**Re: Professional Engineering Opinions
Roxul RAN-5 Facility
WV/NPDES Multi-Sector Stormwater General Permit
Ranson, Jefferson County, West Virginia
Langan Project Number: 270112301**

Opinion 1 – The WV DEP disregarded their own policies, regulations, and best practices as they relate to the management and treatment of stormwater runoff from the RAN-5 Facility.

Opinion 2 – The WV DEP reviewed and approved the RAN-5 Facility's SWPPP and GPP without adequate supporting information to conclude that the measures of these plans protect the environment.

Inset from The SWPPP Figure 2A

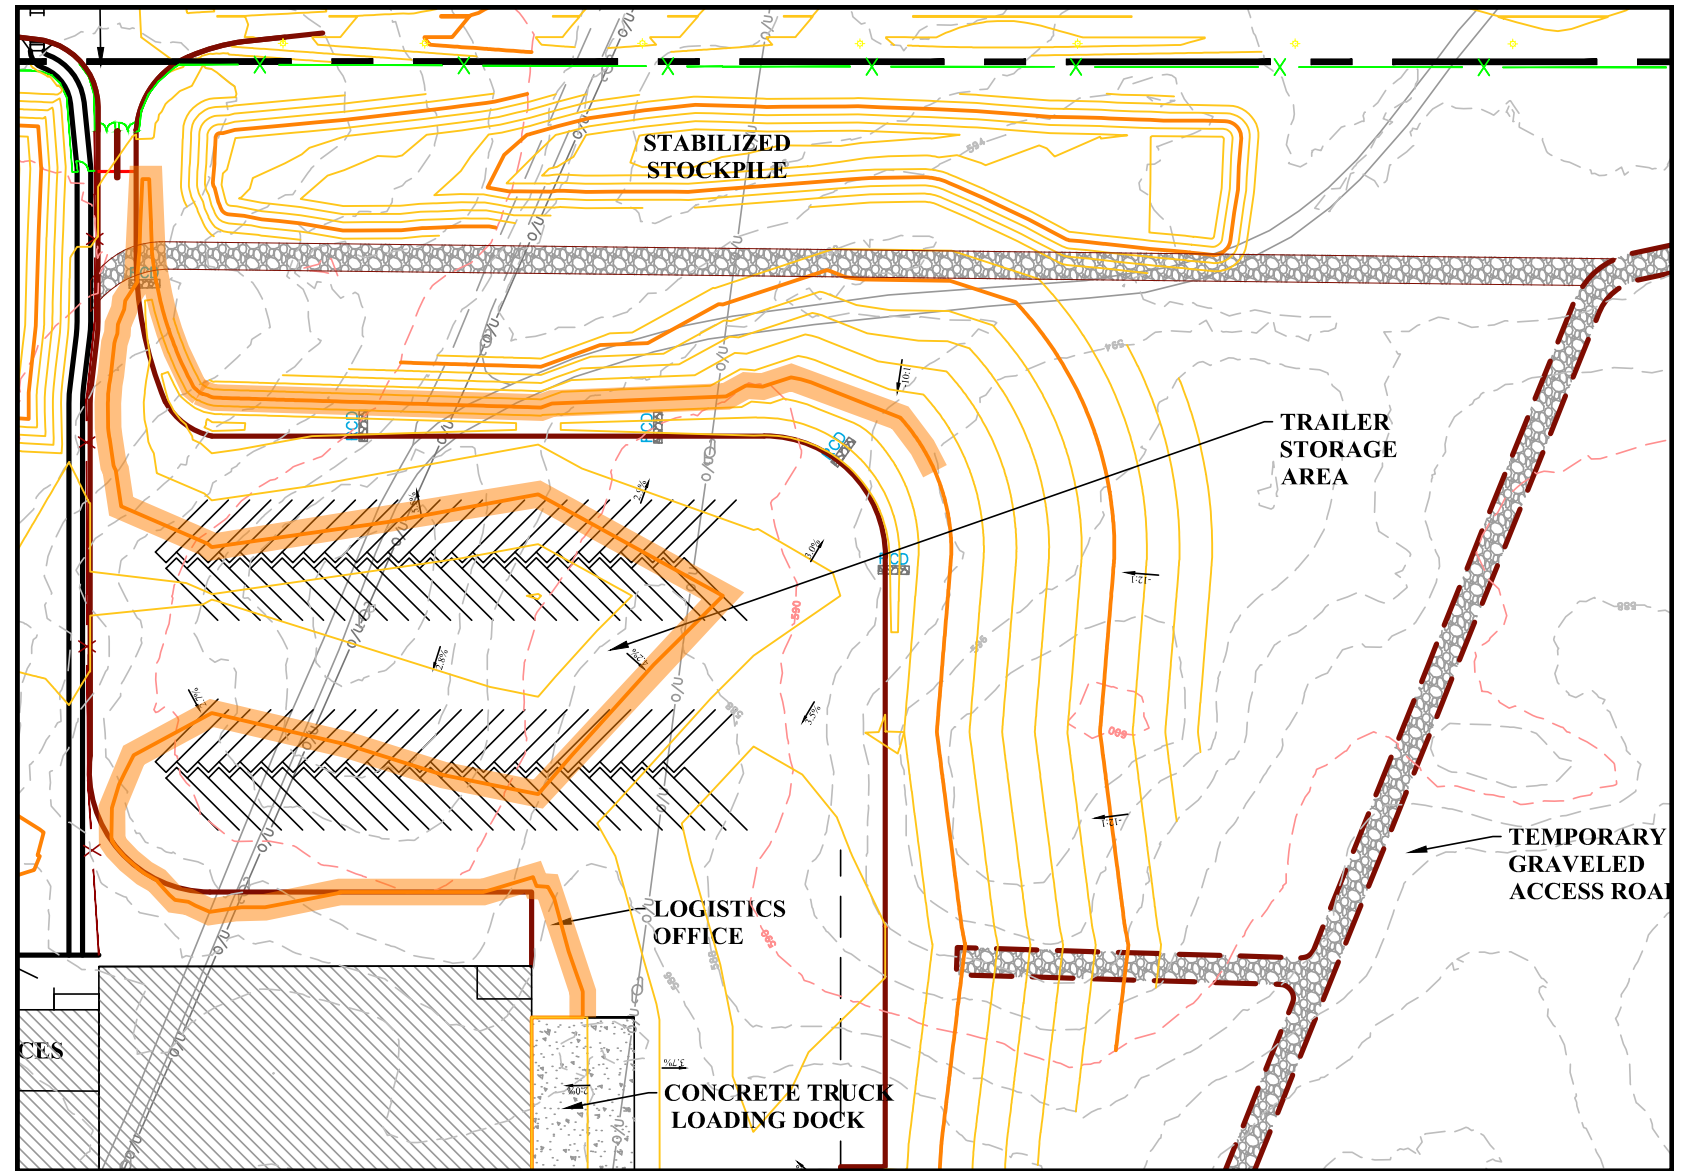
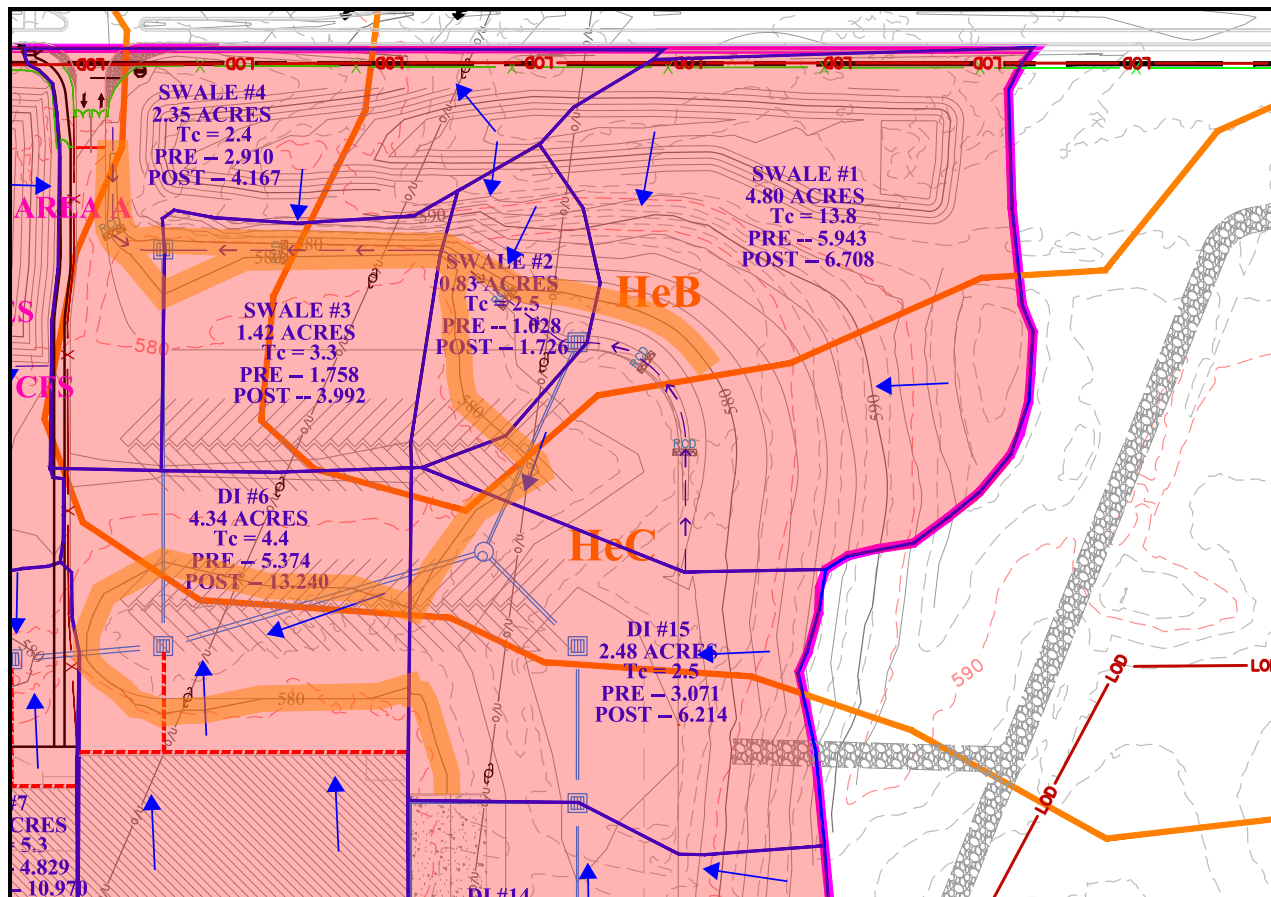
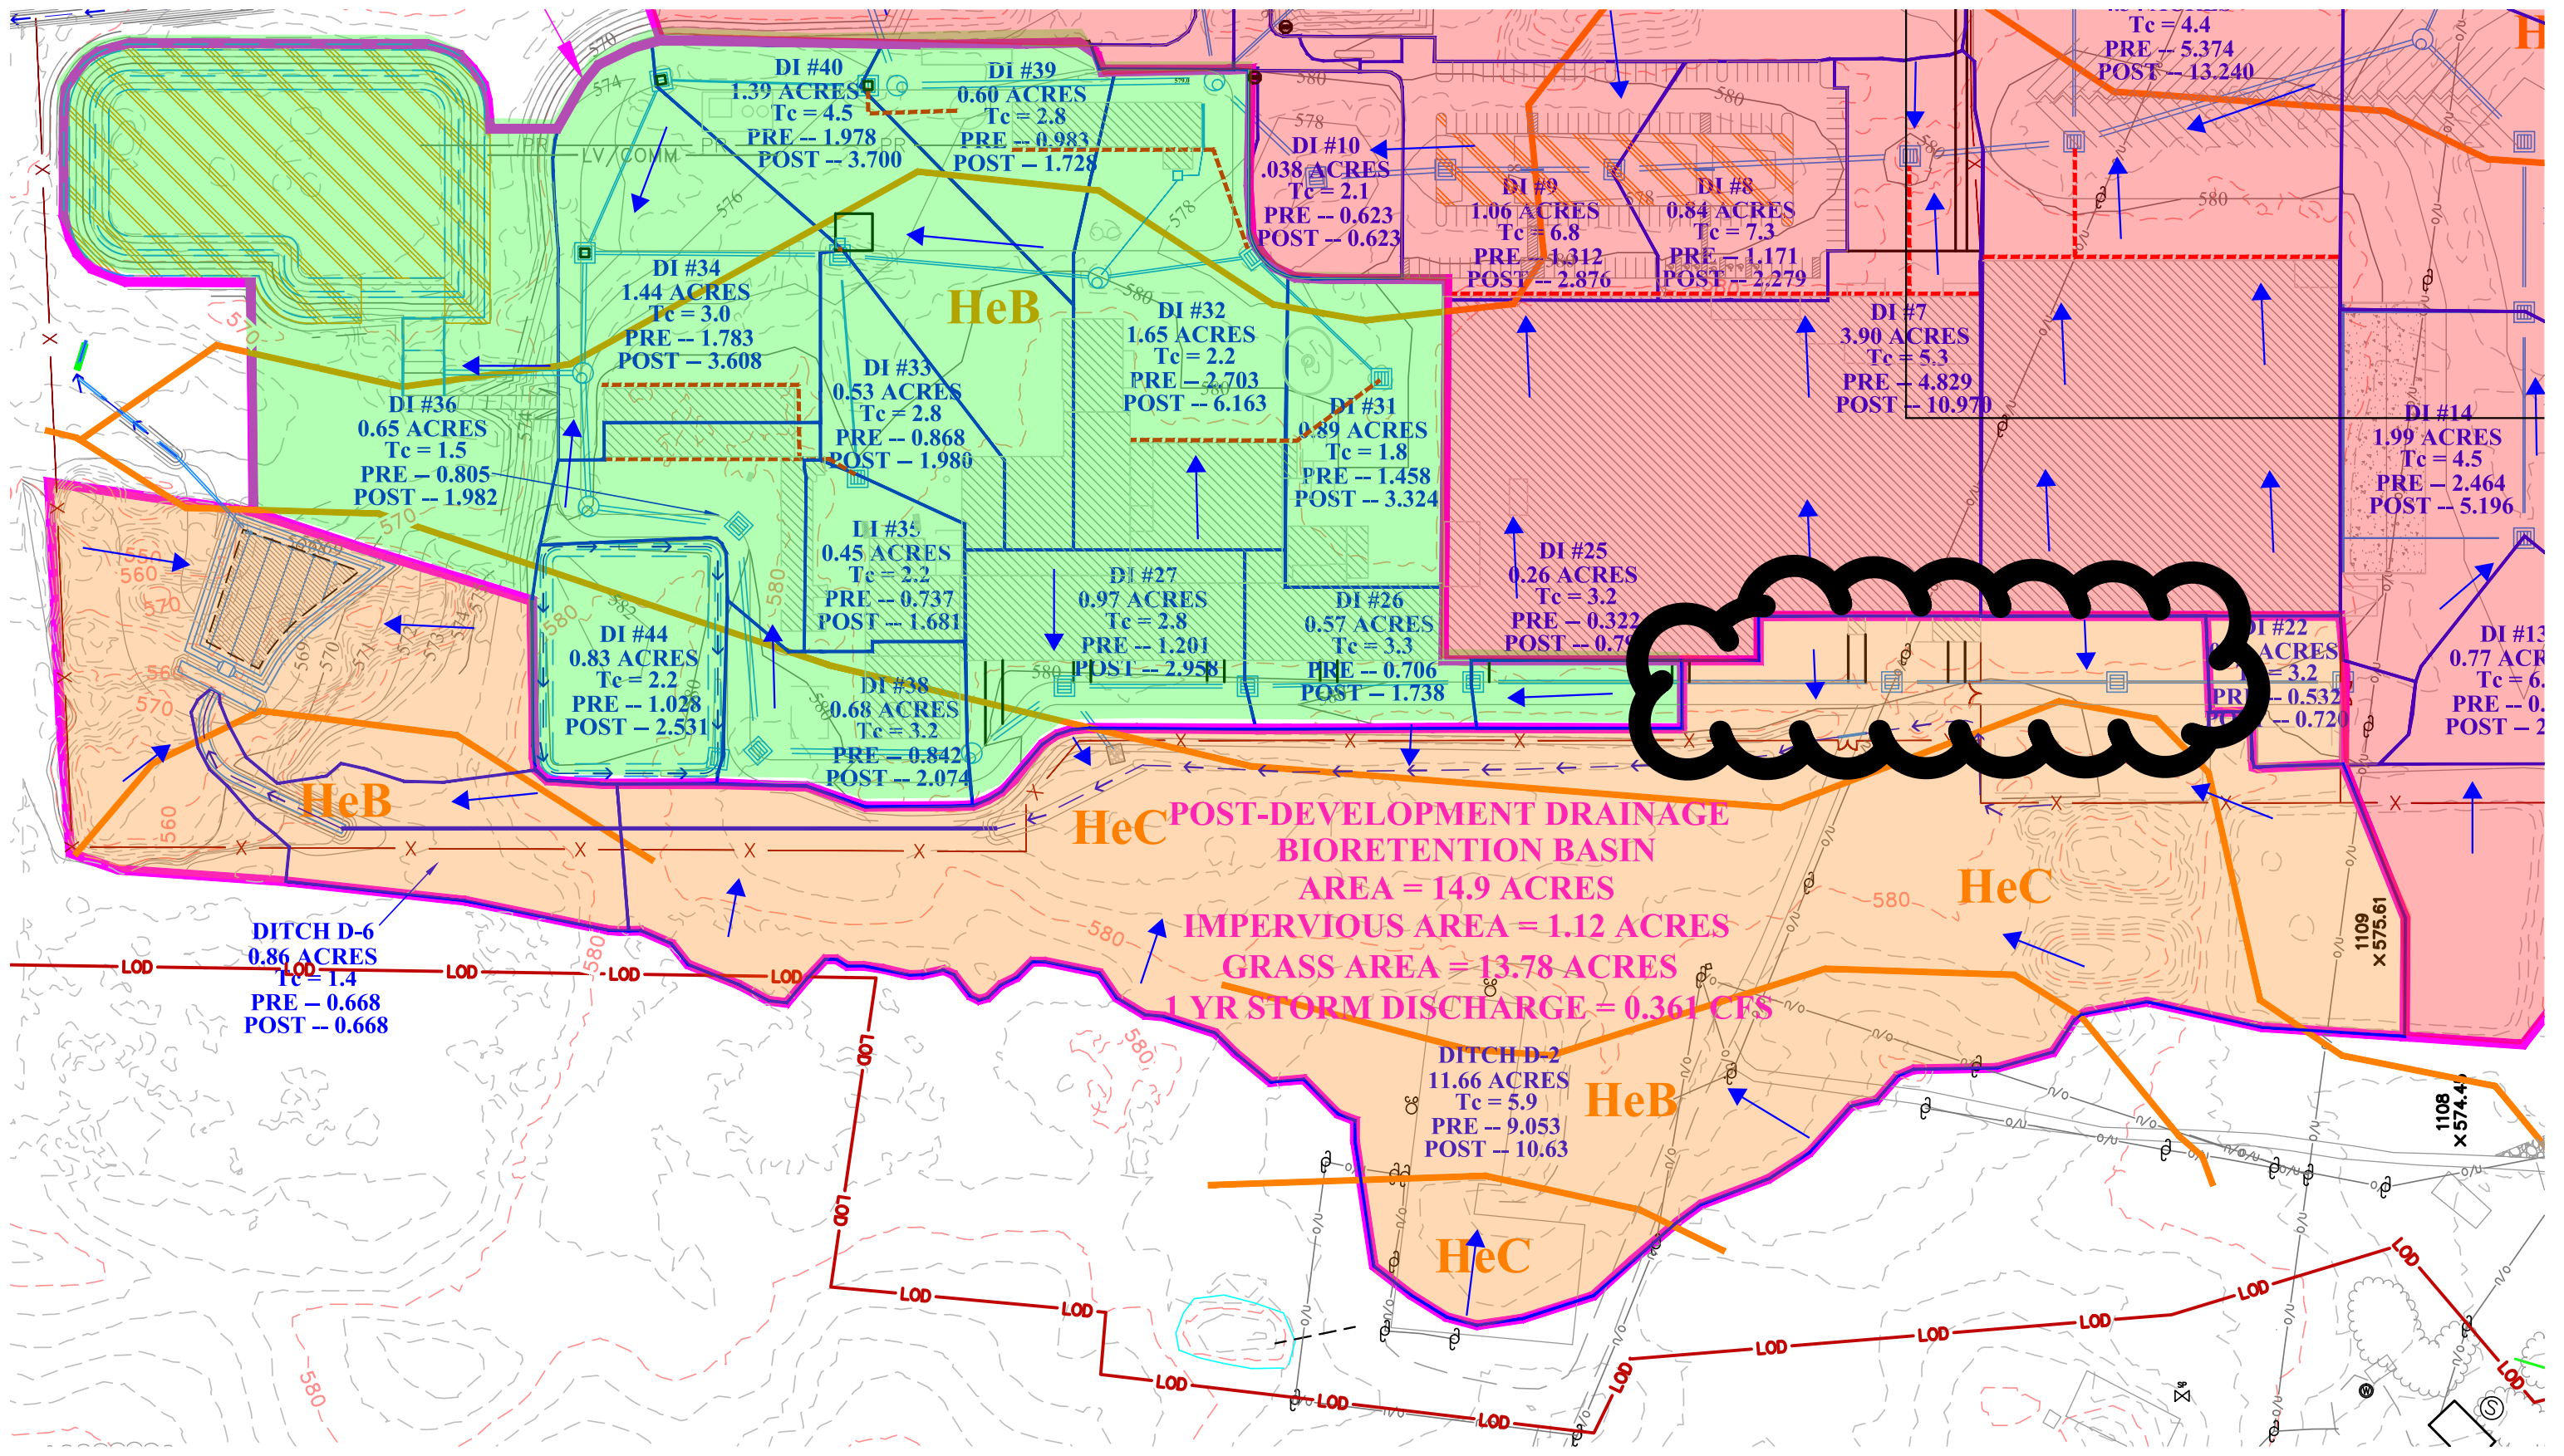
When reviewing Figure 2A and Figure 3 compared to Figure 2B, a clear difference in the grading design and parking lot layout at the southwest area of the site is evident between figures raising questions on the drainage intent of this area; see Exhibit 2-B. This discrepancy should have been inquired about and The SWPPP should not have been approved given the lack of clarity on site runoff patterns. The correct site layout should be shown on all figures as well as a consistent grading design.

EXHIBIT 2B

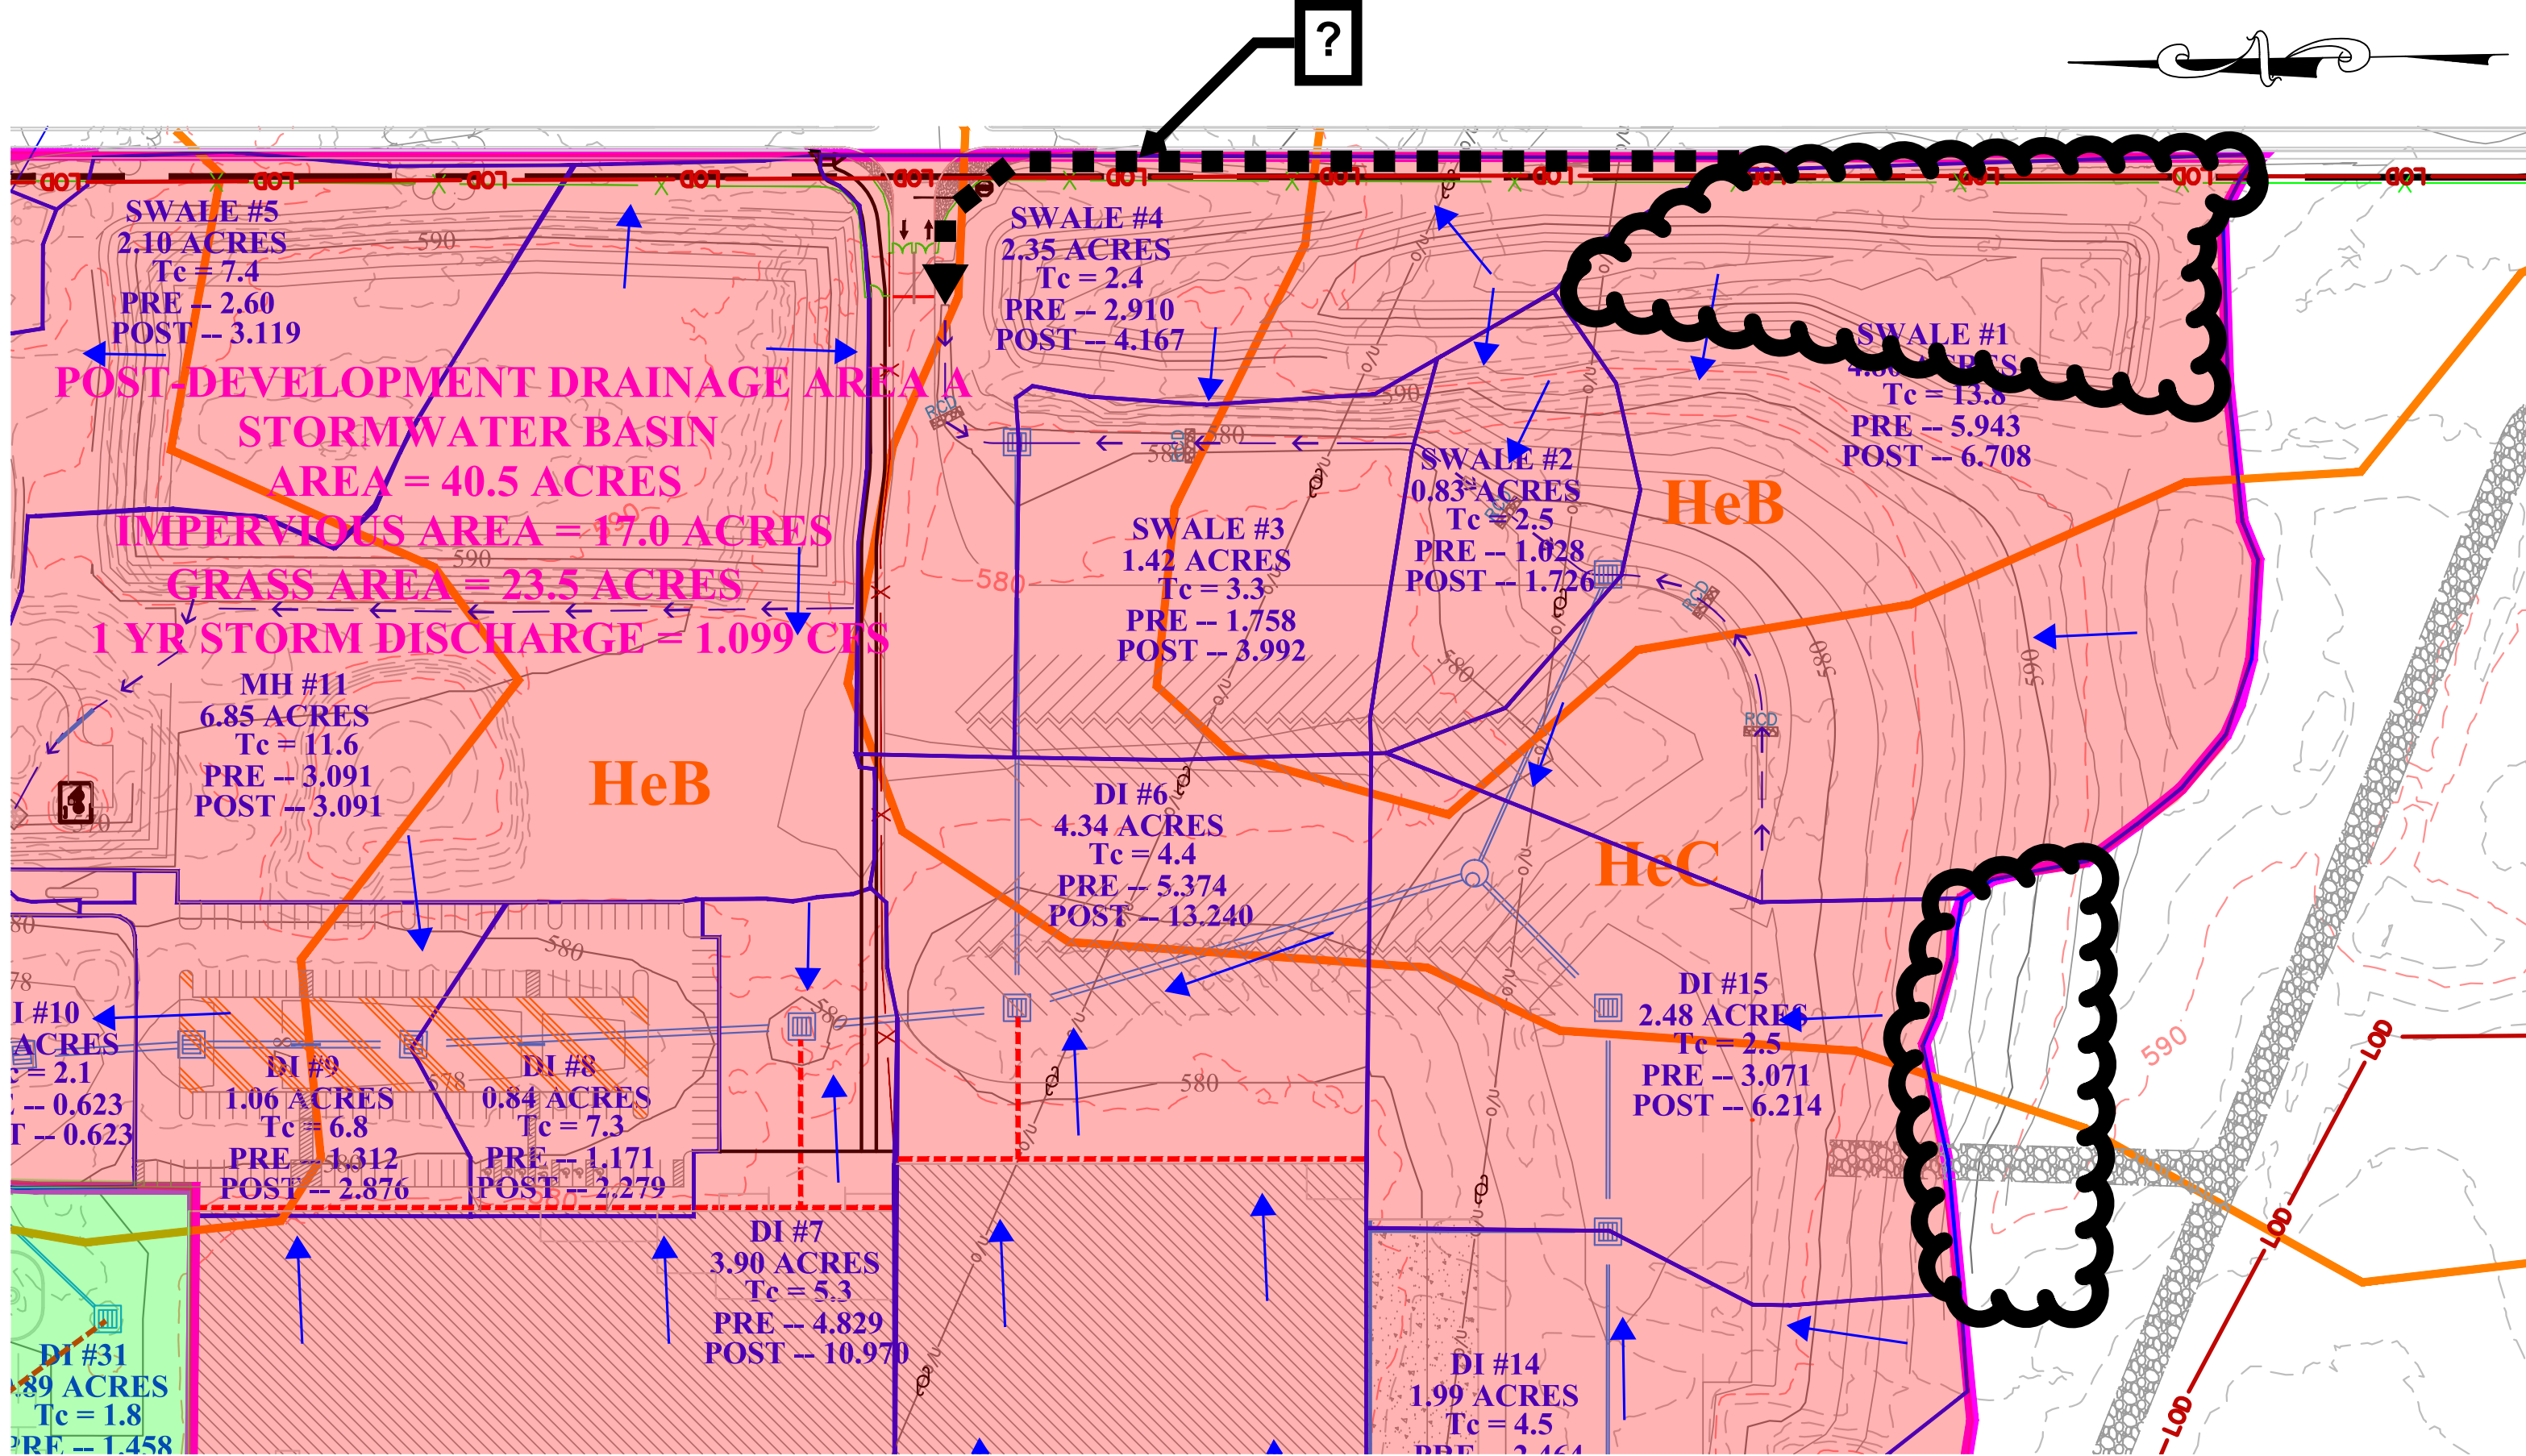
The southern border, which includes drainage inlet (DI) number 15, is not shown correctly. The contours in this area clearly show a minimum of 0.5 acres of additional contributing runoff that was not included to subdrainage area DI#15; see Exhibit 3-B2.
